## ArevaEPRDCPEm Resource

Attached is a DRAFT response for Question 07.01-35 of RAI No. 505 (FSAR Ch. 7) provided in the attached file in advance of the May 30, 2012 final date.

All indicated changes are in response to RAI 505, 07.01-35

Figure 7.3-36—CCWS Emergency Leak Detection - Switchover Valves Leakage or Failure

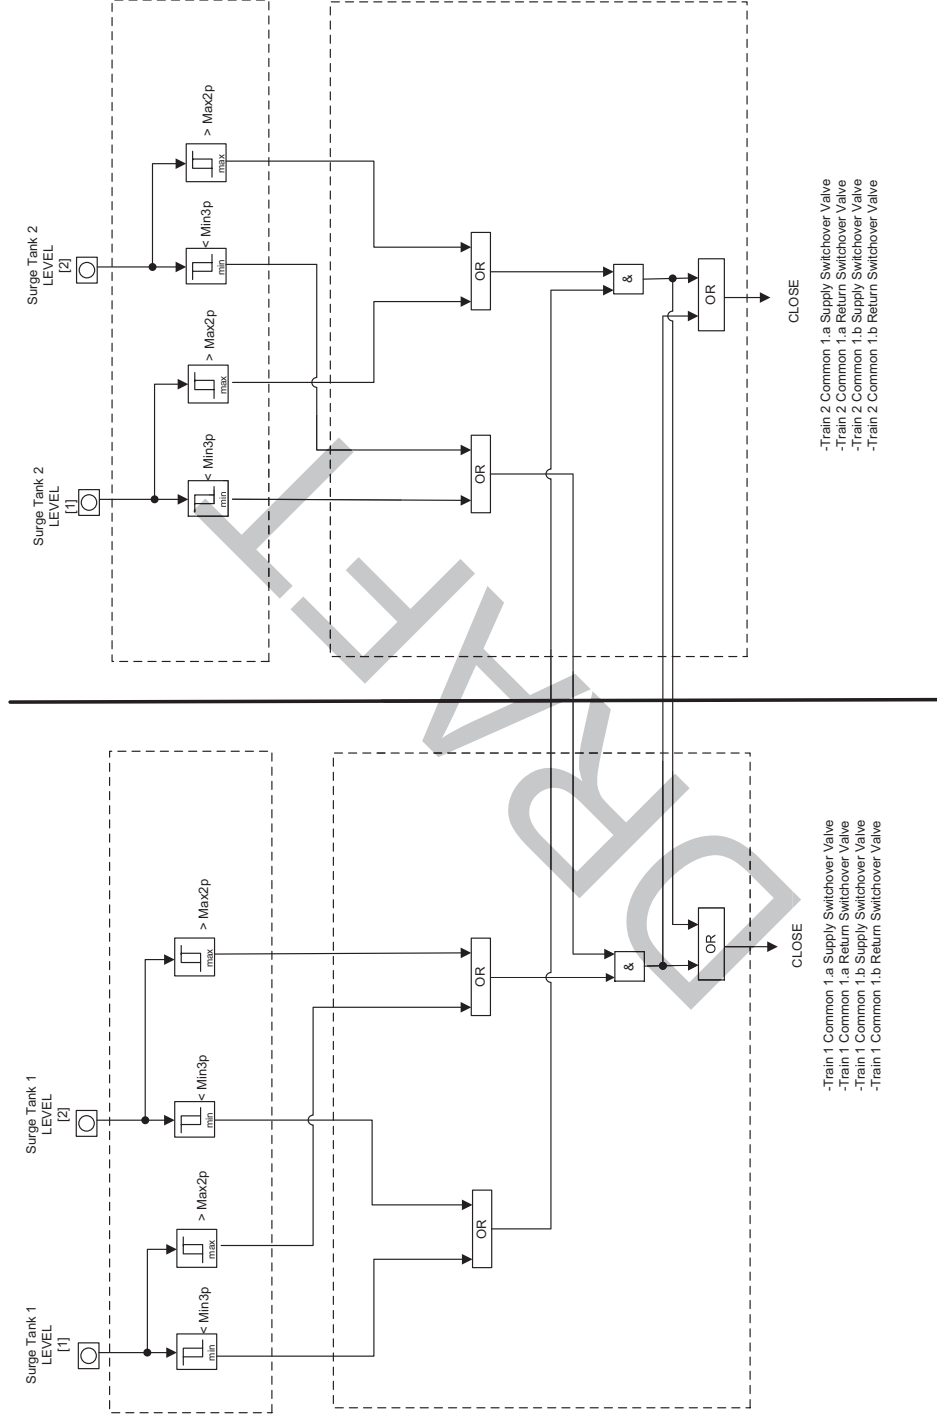
All indicated changes are in response to RAI 505, 07.01-35

Figure 7.3-38—ESWPBVS ESWS Pump Rooms Temperature Control

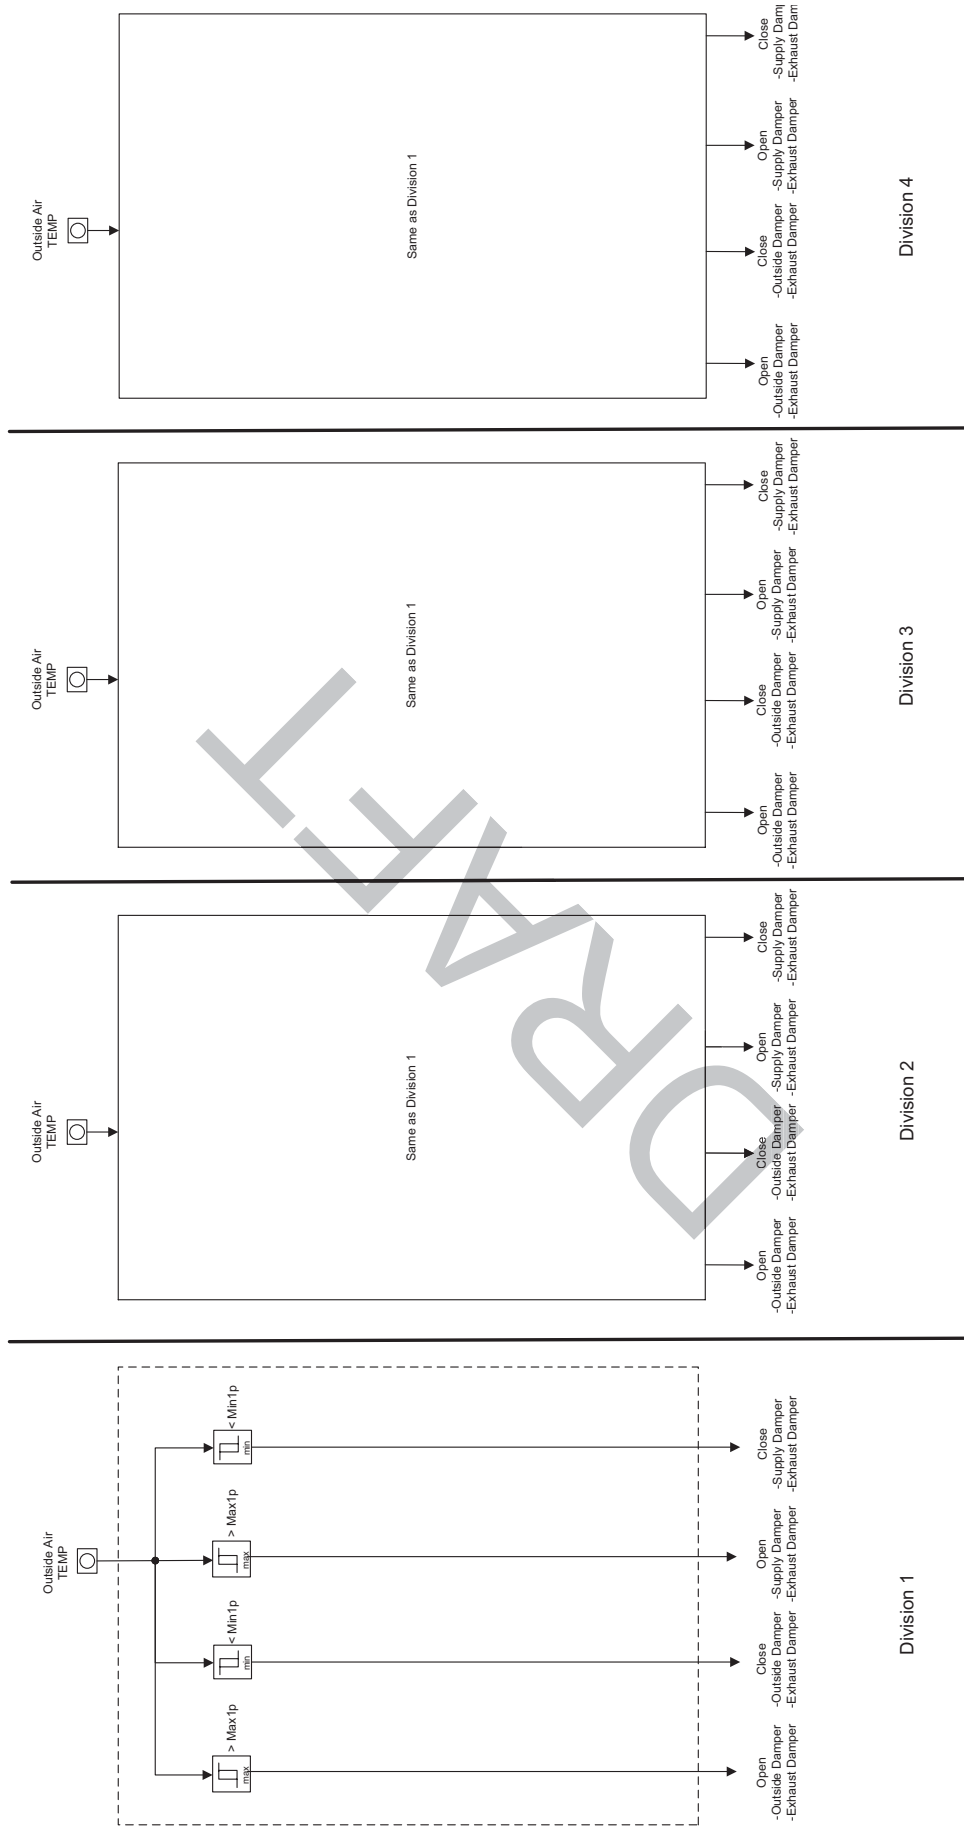
All indicated changes are in response to RAI 505, 07.01-35

Figure 7.3-39—FBVS Safety-Related Rooms Heater Control

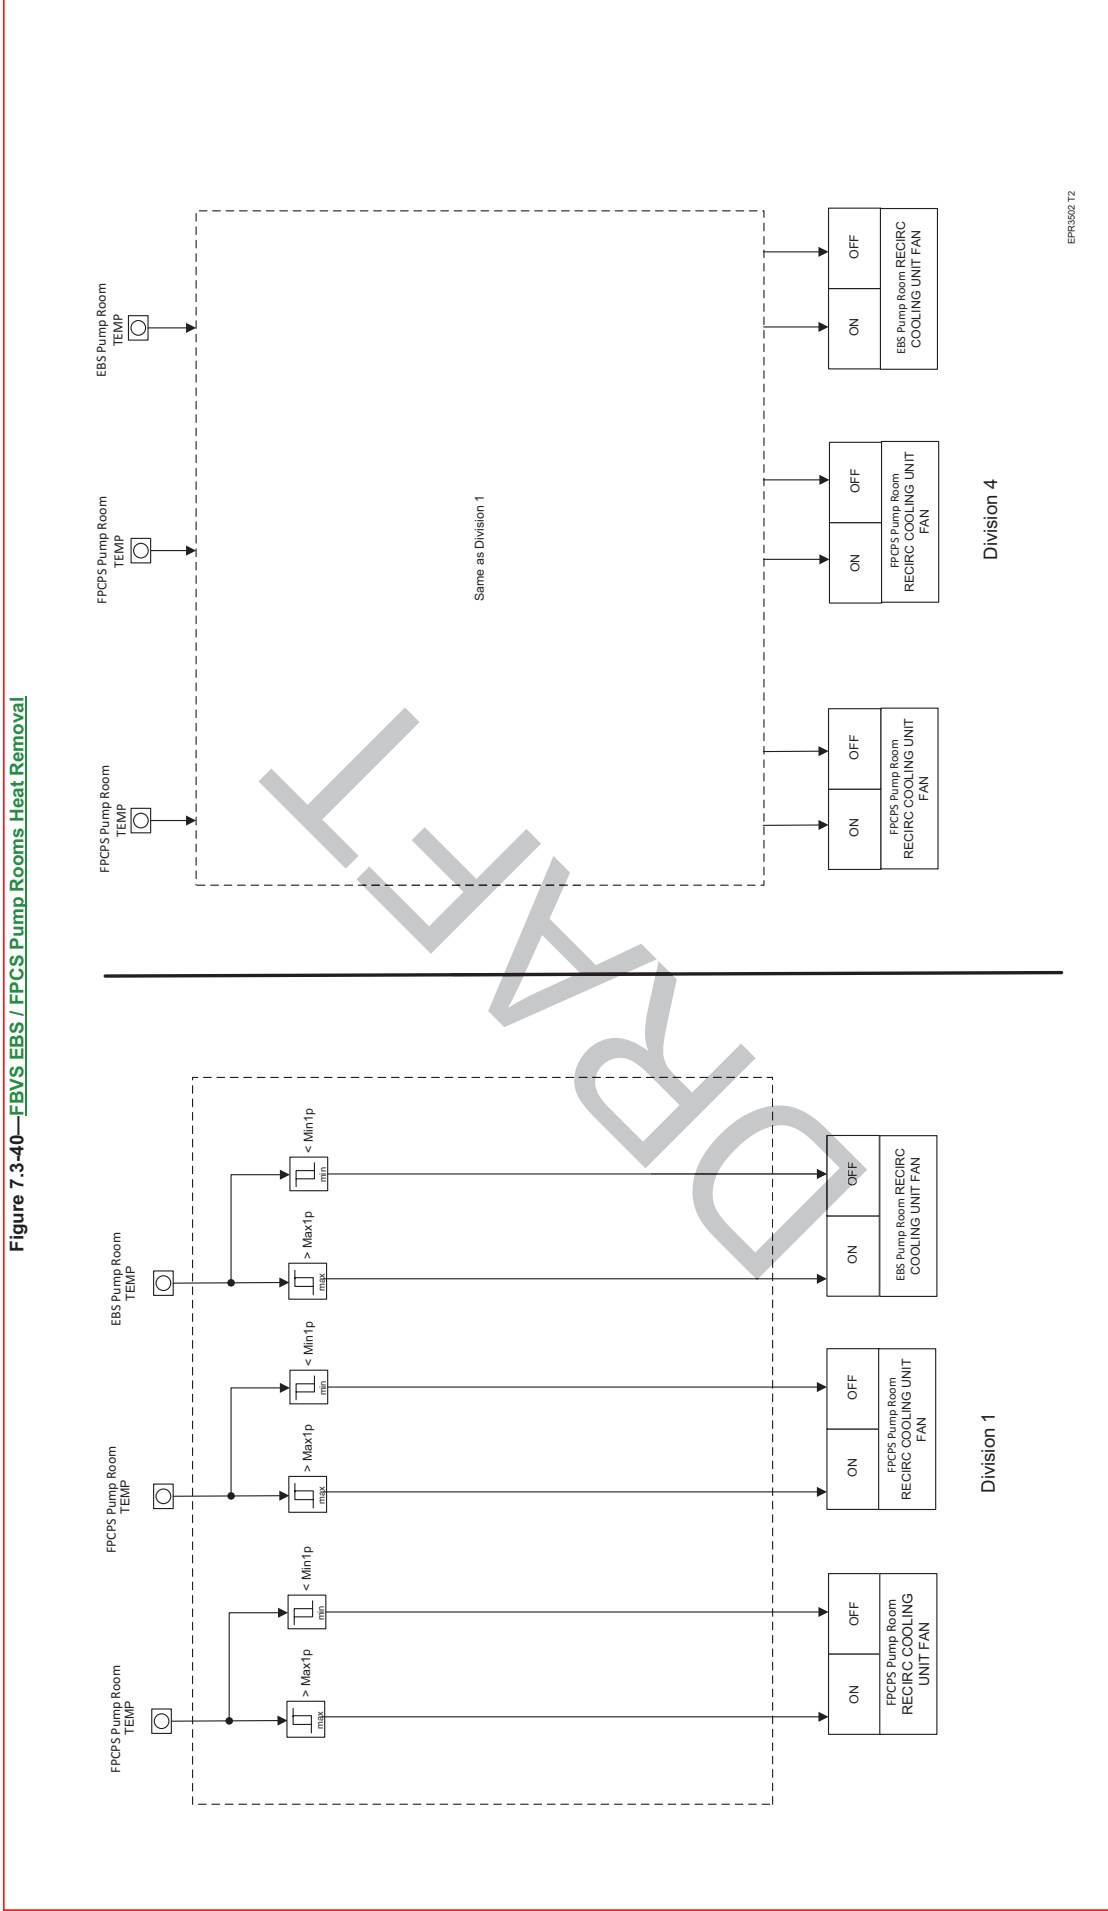
All indicated changes are in response to RAI 505, 07.01-35

Figure 7.3-42—CRACS Iodine Filtration Train Heater Control

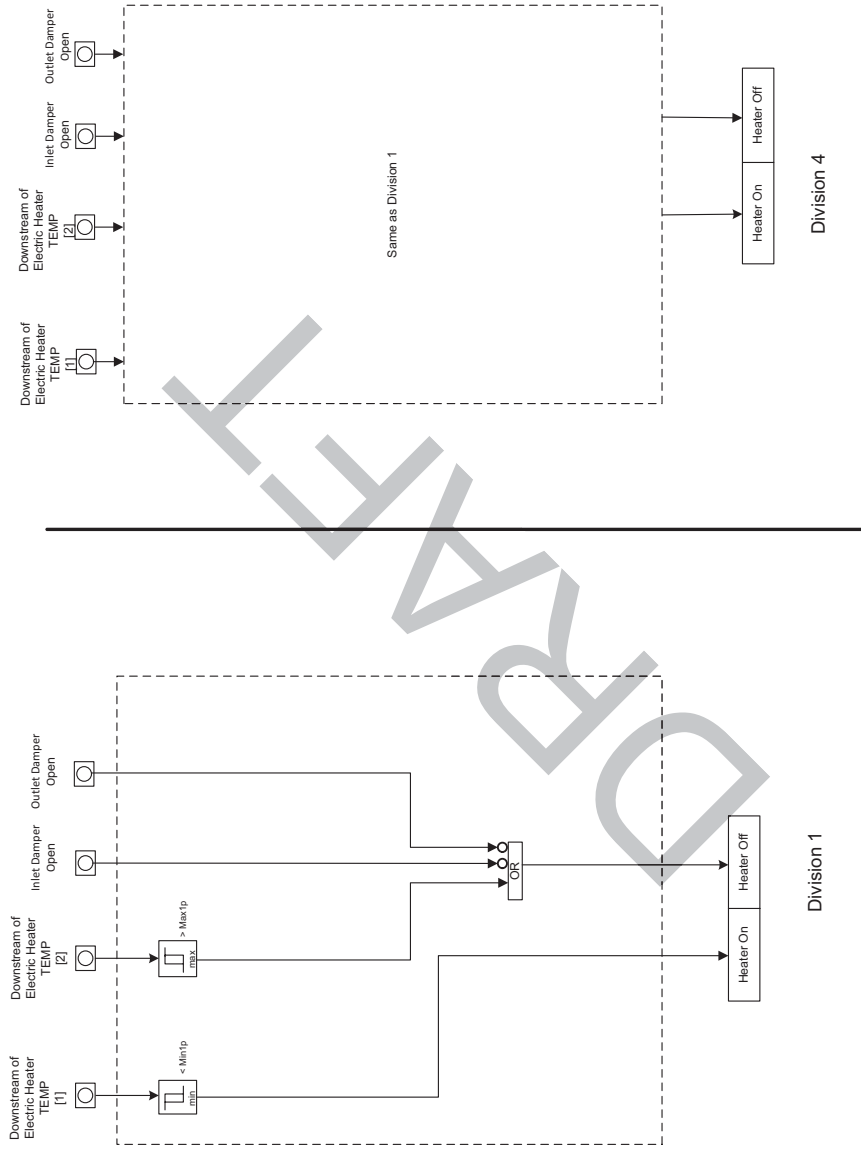
All indicated changes are in response to RAI 505, 07.01-35

Figure 7.3-44—CRACS Pressure Control

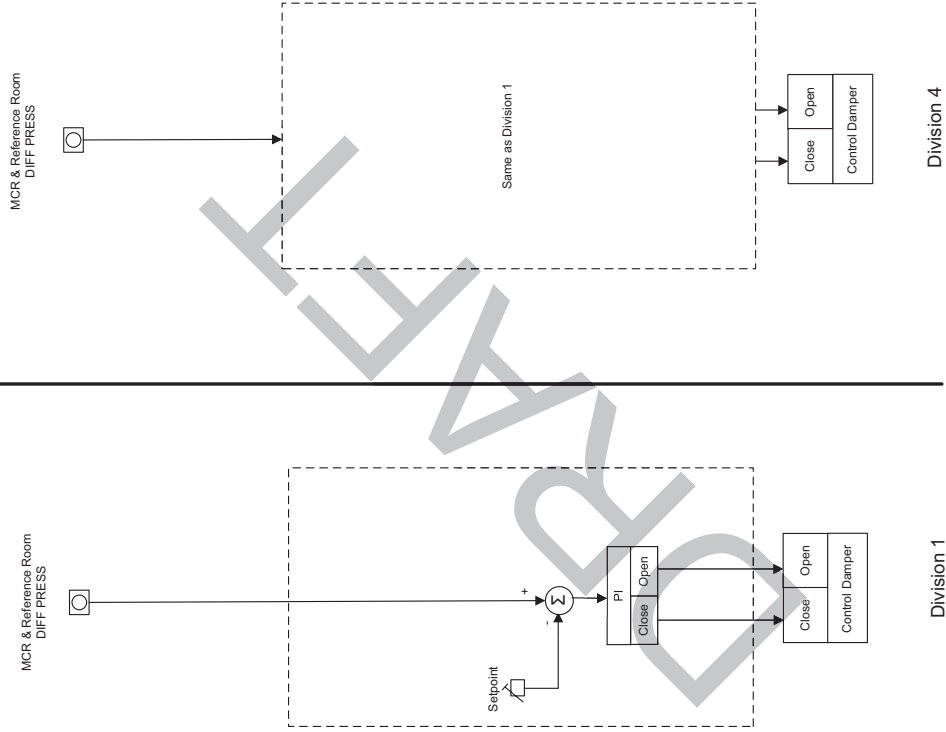
All indicated changes are in response to RAI 505, 07.01-35

Figure 7.3-46—SBVS SIS / RHRs Pump Rooms Heat Removal

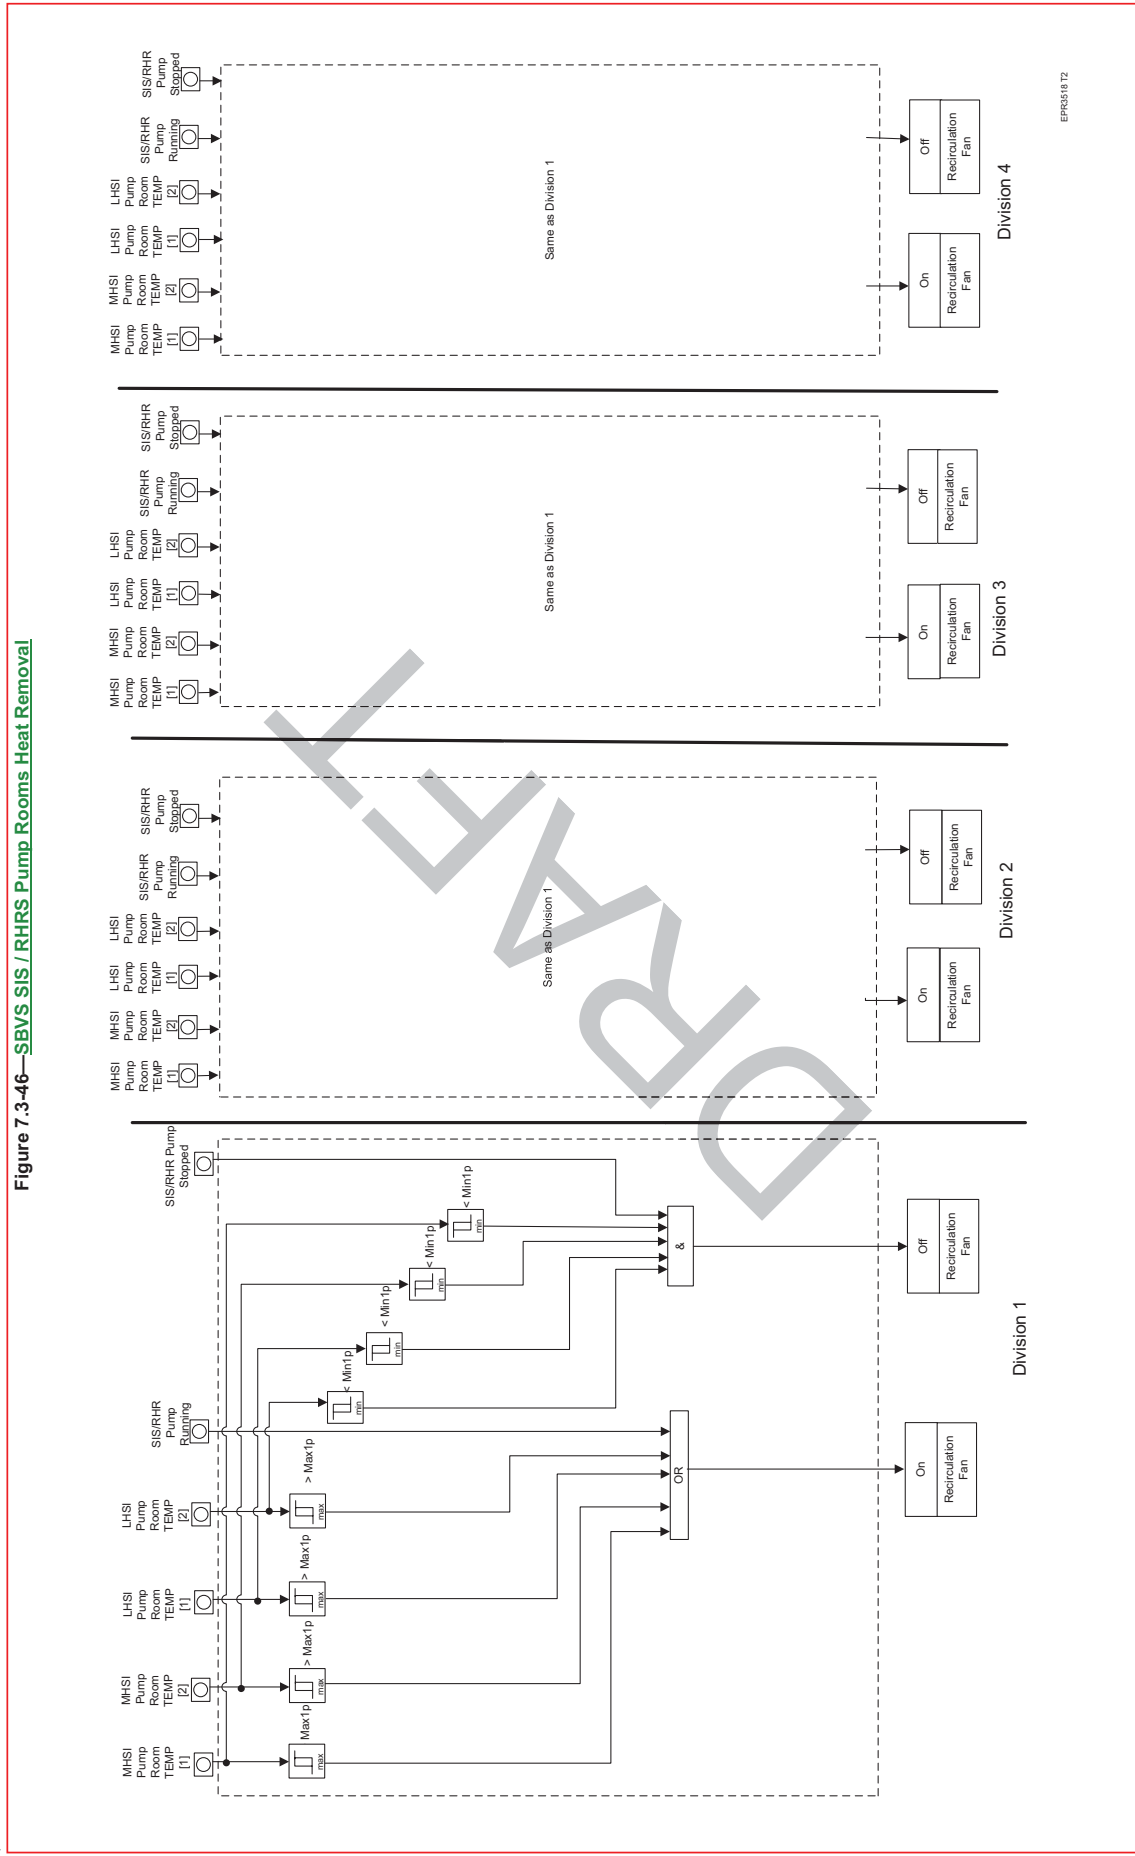
All indicated changes are in response to RAI 505, 07.01-35

Figure 7.3-47—SBVS CCWS / EFWS Valve Rooms Heat Removal

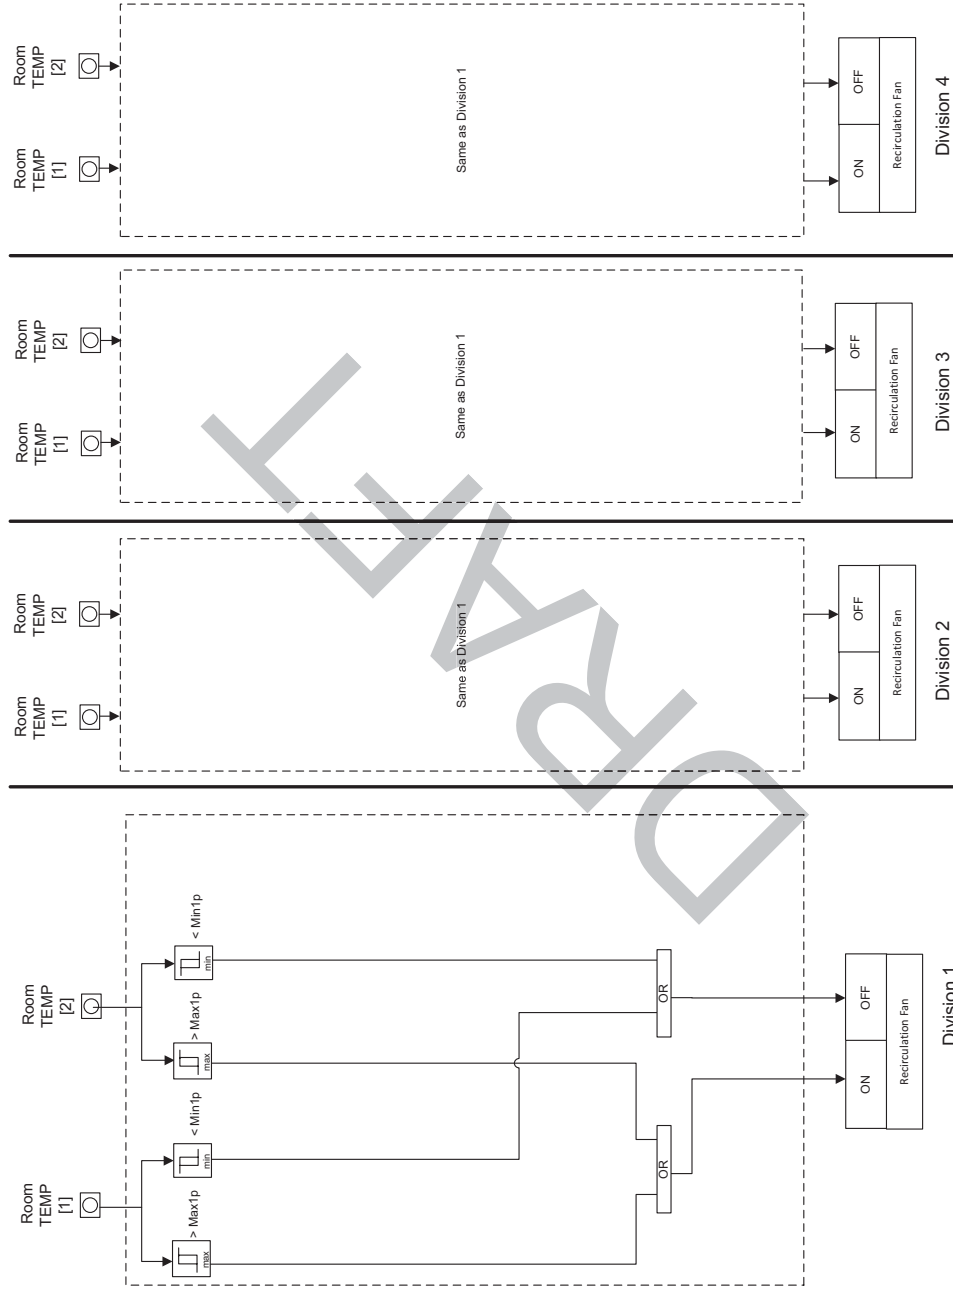
All indicated changes are in response to RAI 505, 07.01-35
